**Public Utilities
Commission of Ohio**

Re: In the matter of the authorization of the Ohio Central Railroad and Norfolk Southern Railway to install active grade crossing warning devices in Muskingum and Seneca Counties

TO: Randall Schumacher, Supervisor, Rail Division, PUCO
FROM: Cathy Stout, Manager, Safety Section, ORDC
BY: James Tucker, Project Manager, ORDC
SUBJECT: Muskingum County, Lee Street
DOT#474109A, PID#99464
DATE: February 22, 2016

TO: Randall Schumacher, Supervisor, Rail Division, PUCO
FROM: Cathy Stout, Manager, Safety Section, ORDC
BY: Don Damron, Project Manager, ORDC
SUBJECT: Seneca County, CR 8 / Norfolk Southern
DOT# 481599L
PID# 99303
DATE: February 25, 2016

TRACK AND CABLE LAYOUT

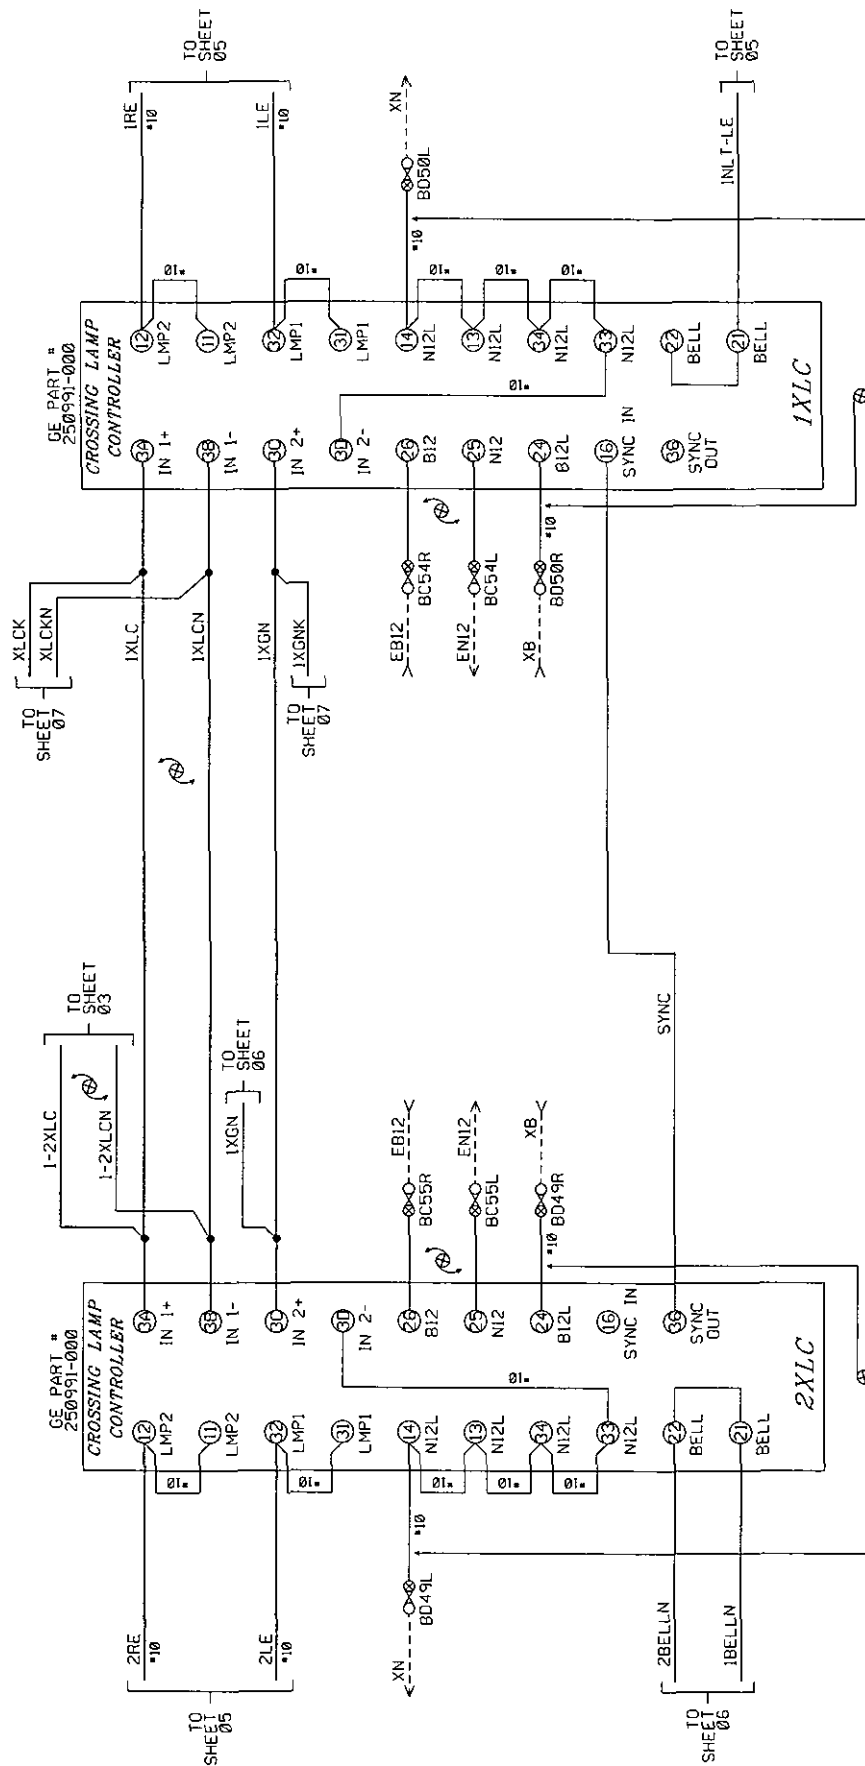
The plan shows the signal masts being located 8'-3" from edge of road, however, there are notations that say "field verify". The Diagnostic Report says there are currently "non-functional" curbs (less than 4" in curb height), but also recommends curbs be installed/replaced. If, in fact, functional curbs are installed/replaced, these dimensions may be reduced to 4'-3" from face of curb as/where appropriate.

Part of what "muddies the water" at this location is the private driveway. Was any consideration given to contacting the landowner to see if this portion of the driveway could possibly be eliminated? There is another entrance for this same driveway along Lee Street approximately 200 (+/-) feet to the SE. Unless there is some compelling reason for keeping the driveway in this configuration, eliminating this leg of it would decidedly shorten the crossing and simplify the signal arrangement. Consider: Is it the Diagnostic Review Team's job to simply "tailor" some traffic control device arrangement to "fit" whatever situation they may find? Isn't it also to generate/promote ideas on how to uncomplicate the situation so that the resultant traffic control device installation is simpler, safer and possibly less costly?
